REMARKS

Claims 1-9 are pending.

FIG.2

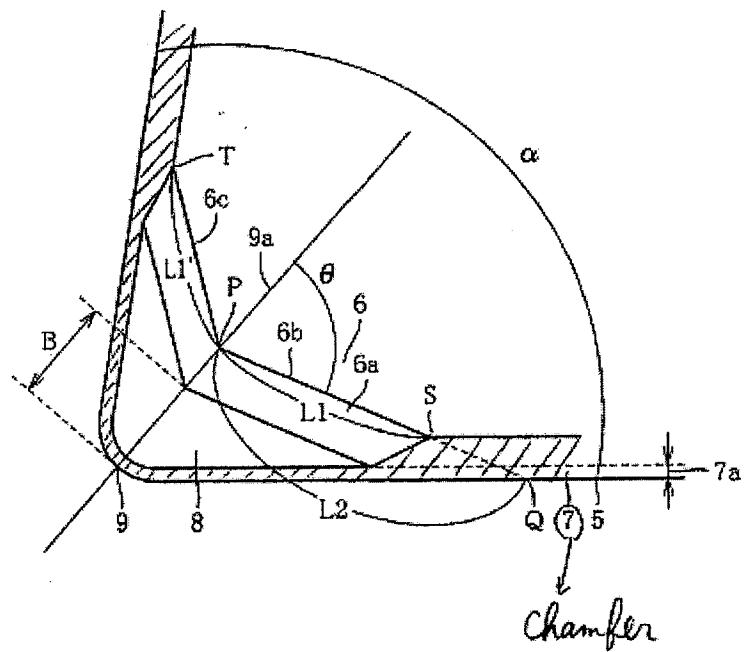
The drawings are objected to under 35 C.F.R. § 1.83(a). The Office Action states that the drawings must show every feature of the invention specified in the claims. The Examiner contends that the “pair of ridges *reaching said chamfer*, the pair of ridges are on the apex of said protrusion” must be shown or the features canceled from the claims. This objection is traversed.

Claims 1-9 are rejected under 35 U.S.C. §112, first paragraph, as failing to comply with the written description requirement. It was alleged that the claims contain subject matter which was not described in the specification in such a way as to reasonably convey to one skilled in the relevant art that the inventors, at the time the application was filed, had possession of the claimed invention. The Examiner concludes that Reference No. 7 corresponds to the chamfer and Reference Nos. 6b, 6c correspond to the pair of ridges. The Examiner contends that the ridges 6b and 6c do not actually reach the chamfer. Applicants traverse.

Claims 1-9 are rejected under 35 U.S.C. § 112, second paragraph, as indefinite for failing to particularly point out and distinctly claim the subject matter which applicant regards as the invention. The Examiner concludes that he will interpret the claimed “pair of ridges *reaching said chamfer*, the pair of ridges are on the apex of said protrusion” as a pair of ridges directed towards the nose of the insert.

The Office Action has failed to provide any basis for asserting that the drawings do not show that the “pair of ridges *reaching said chamfer*, the pair of ridges are on the apex of said protrusion.” According to one aspect of the present subject matter, as described in independent claim 1 and depicted in the representative drawing of Fig. 2 below, the shaded portion corresponds to the claimed chamfer 7.

In view of Fig. 2 and the corresponding description, the width of the chamfer 7 on the backside is wider than that on the forward end side and the ridges (6b, 6c) that reach the chamfer 7 on the backside. Fig. 2 shows, for example, that the pair of ridges reach the chamfer and are on the apex of the protrusion. Thus, the Examiner has no basis for asserting that the “pair of ridges *reaching said chamfer*, the pair of ridges are on the apex of said protrusion” is not shown. Withdrawal of the foregoing objection is therefore respectfully requested.

Claim 1 is fully supported in the written description, specifically, Fig. 2 and page 13, lines 4-9. See previous remarks in response to the drawing objection.
